# THE MARINE WORKS (ENVIRONMENTAL IMPACT ASSESSMENT) REGULATIONS 2007 (AS AMENDED) MARINE LICENCE APPLICATION CML2365 – HYNET CARBON DIOXIDE TRANSPORTATION AND STORAGE PROJECT – OFFSHORE

**Applicant response to Request for Further Clarification dated 11 October 2024.**

Figure 24.8: AIS Tracks in Proximity to the Port of Mostyn – (12 Months)

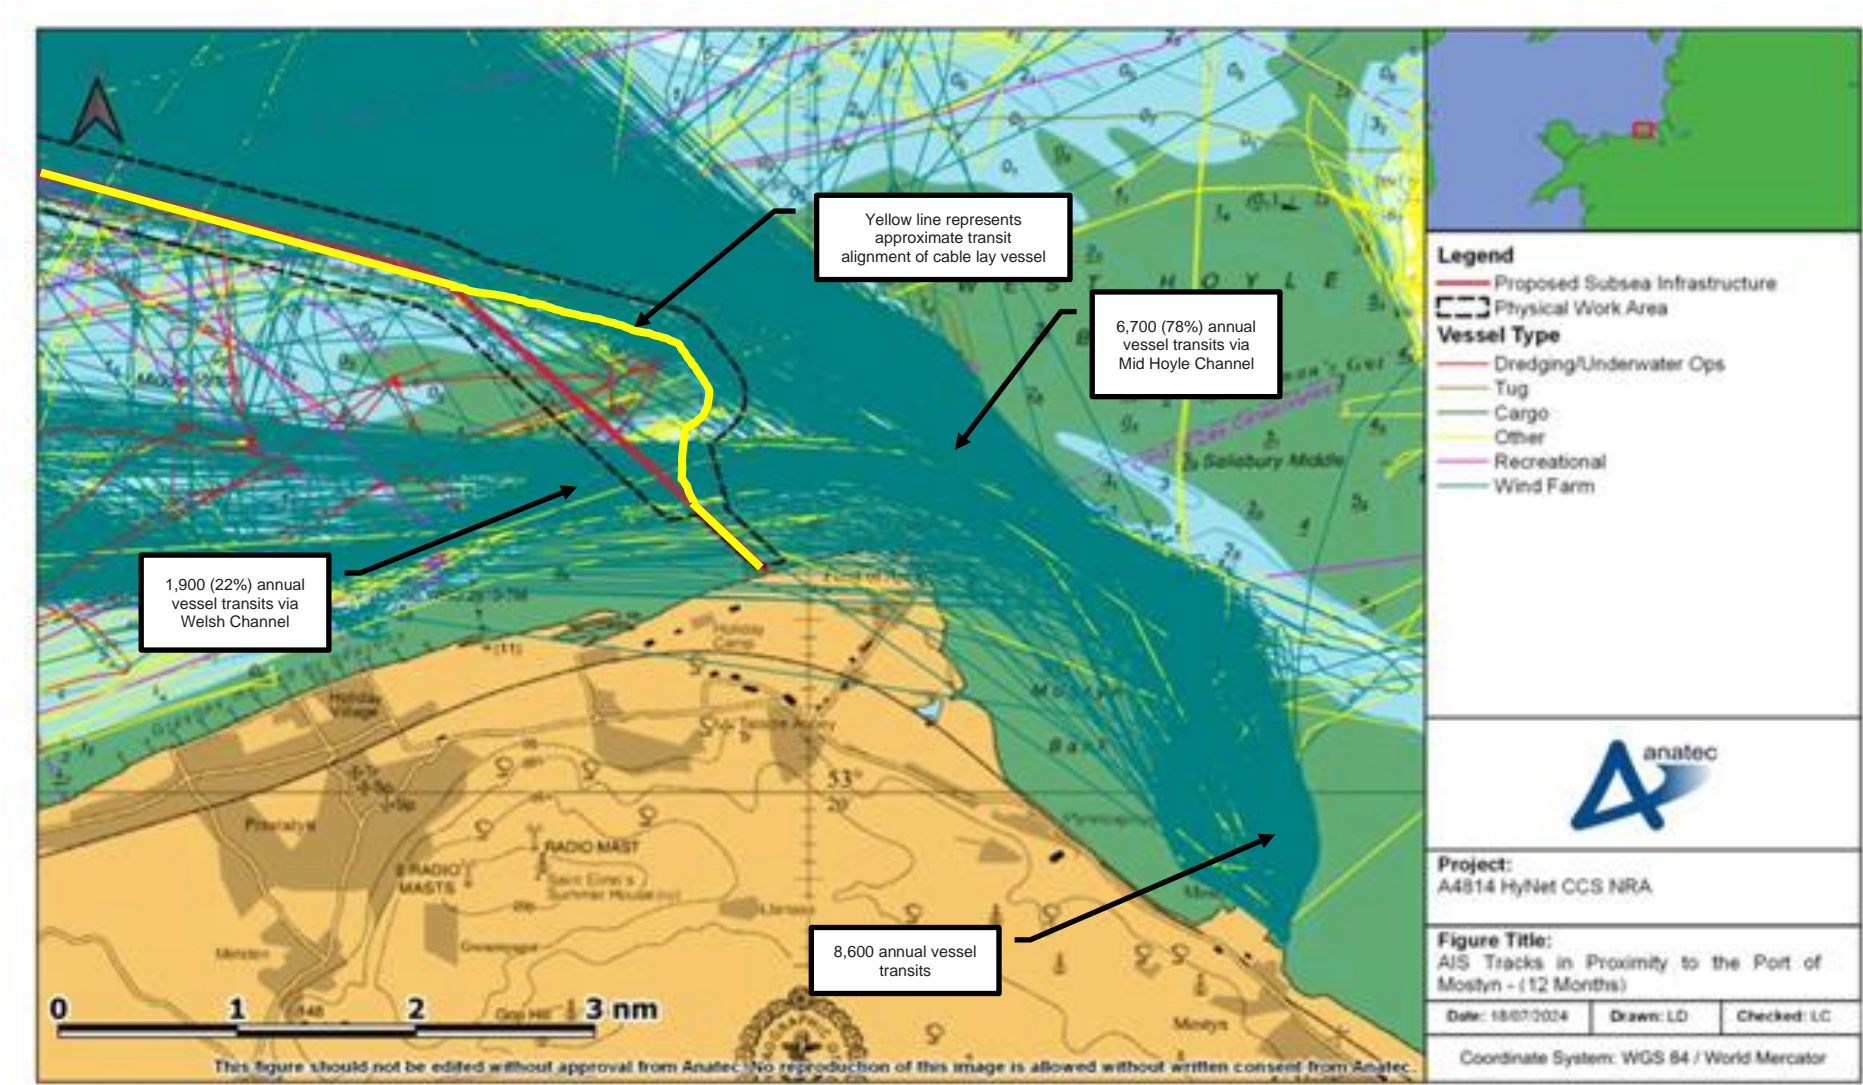
**Action required:** Please clarify timing restrictions and confirm the plans in which these timing restrictions are proposed to be secured.

**Figure 24.8** presents the tracks of vessels recorded on AIS in proximity to the Port of Mostyn, colour-coded by vessel type. During 2022, there were 4,089 vessel tracks recorded on AIS entering or exiting the Port of Mostyn, noting that this excludes temporary vessel activities such as survey and buoy work in the approaches to the Port of Mostyn and in Liverpool Bay. Wind farm support vessels made up the vast majority (99%) of vessels visiting Mostyn, with the remainder made up of tugs, workboats, cargo vessels and RNLI lifeboats.

**Figure 24.8** shows that vessels recorded on AIS used two main routes to access Mostyn. Vessels either follow the Welsh Channel extending to the west out of the River Dee, or the Mid Hoyle Channel, which passes north, through the gap between the West Hoyle Spit and the West Hoyle Bank. The Welsh Channel is crossed by the Proposed Development, partly alongside the existing PL1030 natural gas pipeline, crosses the Welsh Channel and then through the Mid Hoyle Channel. Both channels are buoyed, with the pilot boarding location lying where both channels converge, before entry to the Dee estuary. Of the annual vessel transits recorded on AIS, 6,700 (78%) were transiting the Mid Hoyle Channel, with 1,900 (22%) recorded on AIS using the Welsh Channel. **Figure 24.9** presents a composite of **Figure 24.7** and **Figure 24.8**. In **Figure 24.9** the observations from the 2023 little tern foraging survey have been overlaid on the AIS transits shown in **Figure 24.8**. This shows that all the vessels transiting from Port of Mostyn pass through the foraging area for the little tern colony at Talacre Beach, and approximately 1,900 pass through the Welsh Channel, and hence the foraging area of the Gronant Dunes colony.
